Moser Pass At Denali Final Development Plan

REQUEST: The applicant is seeking approval of final development plan and final plat by demonstrating compliance with all conditions of approval that are specifically required. This submittal specifically addresses the incompleteness items included in the October 24, 2023, incompleteness letter.

II. INCOMPLETENESS LETTER ITEMS

LOCATED IN THE NW 1/4 OF SECTION 33,
TOWNSHIP 2 SOUTH, RANGE 1 WEST, W.M.,
CITY OF SHERWOOD, WASHINGTON COUNTY, OREGON
DATED: NOVEMBER 26, 2023

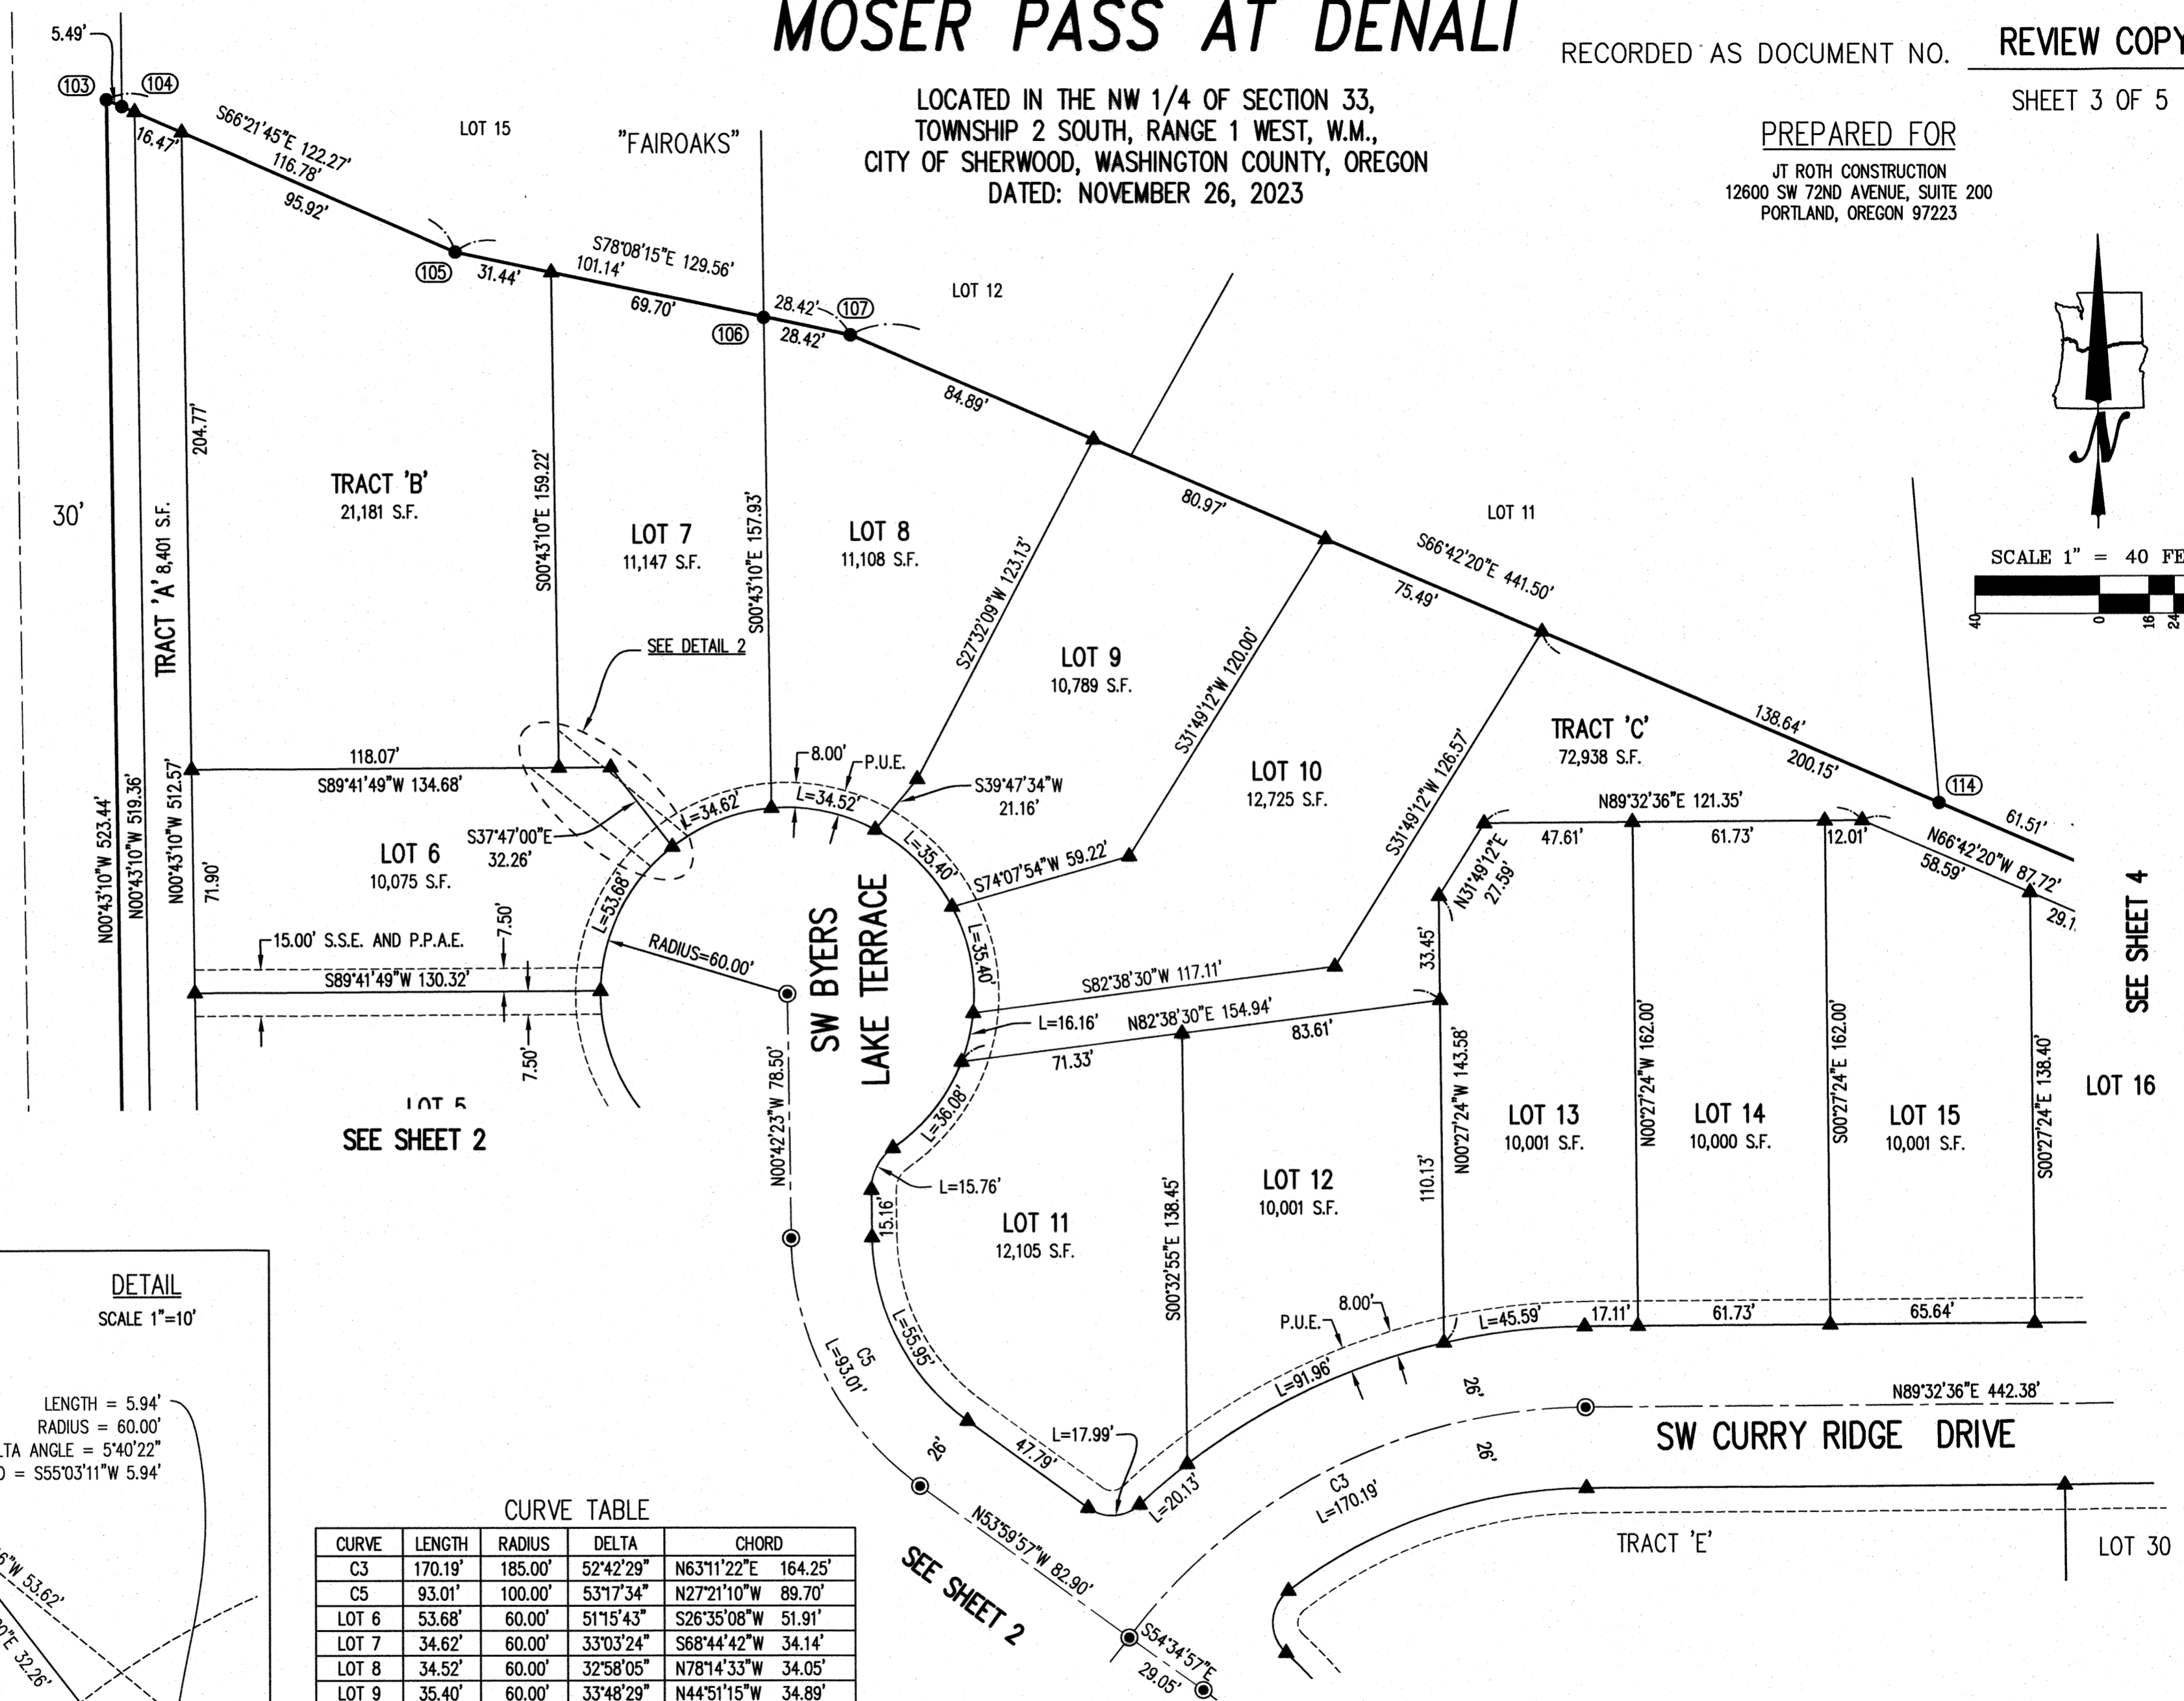
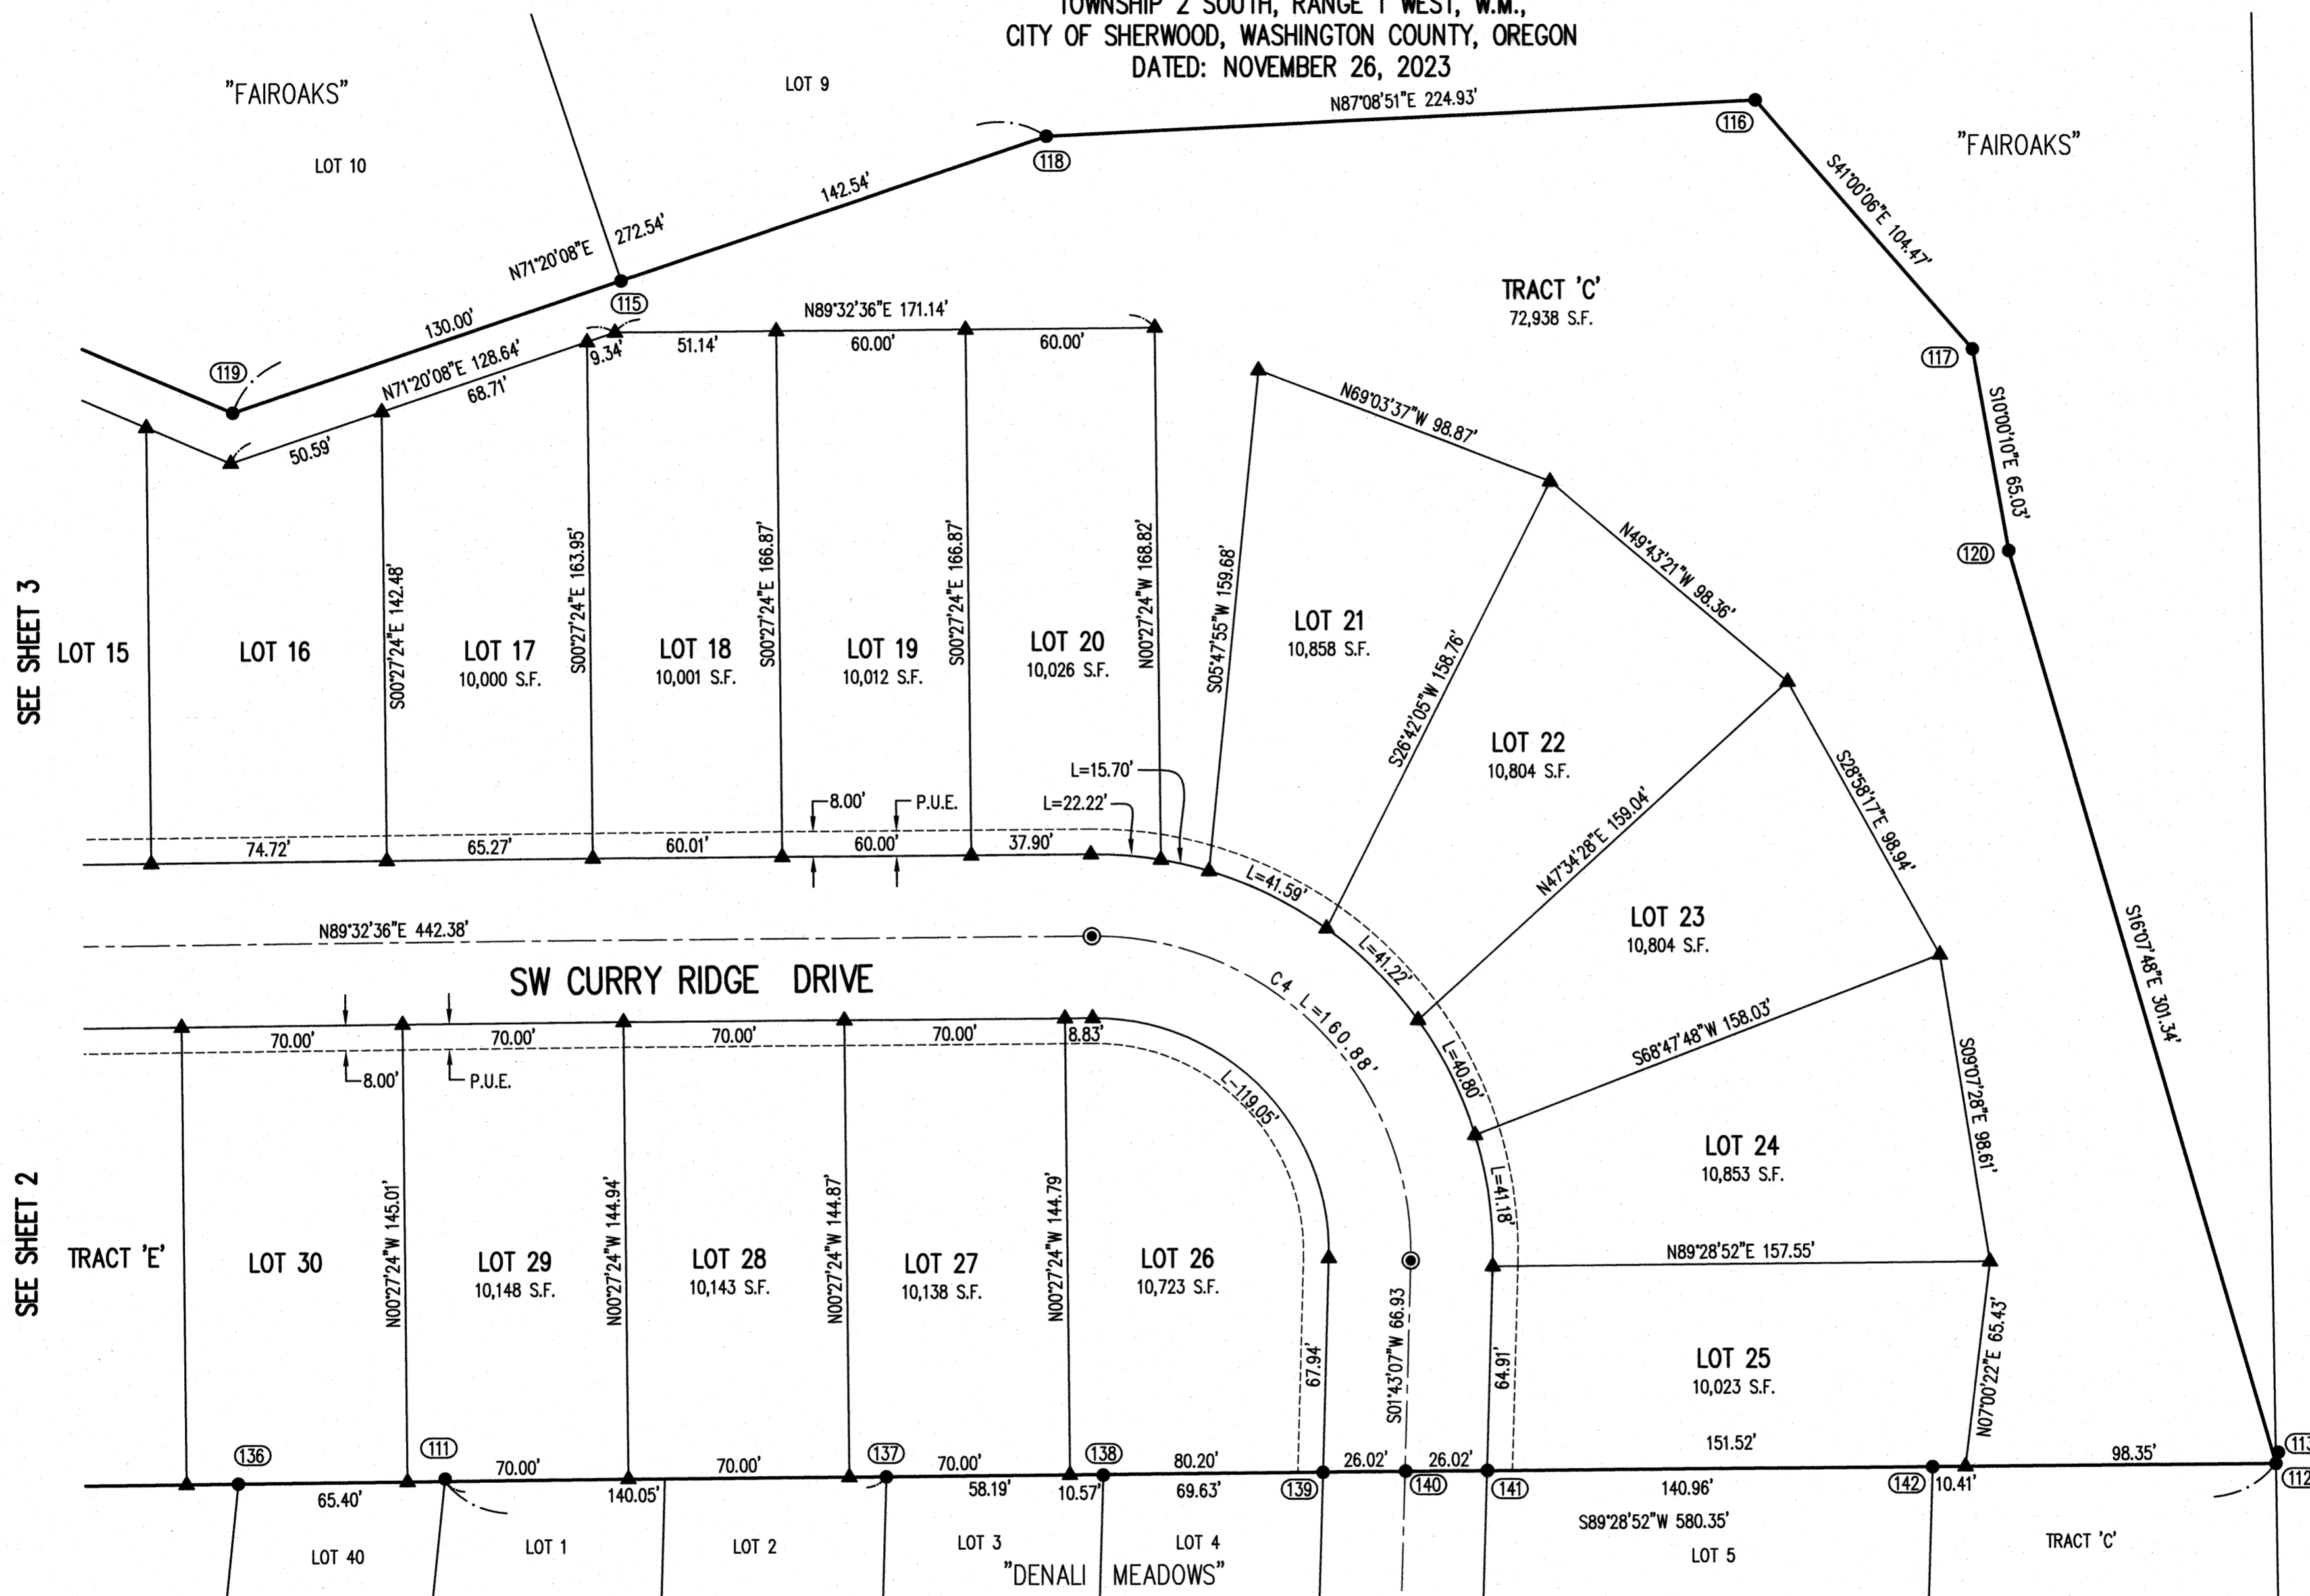
- 1. Sherwood Engineering Department reviewed the plat stating that necessary easements for city utilities need to match the submitted engineering plans (see attached). The Plat should also label all the Open Space Tracts (Tract C and Tract D missing labels).**
- 2. Plat Declaration Page and Plat Notes needs to be submitted.**
- 3. The application identified the plat as “Tentative”. Please submit the latest with the above requested changes.**

Applicant Response: A final plat prepared by a licensed surveyor has been included with this submittal. The submitted plat labels all tracts, easements and ‘Tentative’ have been removed.
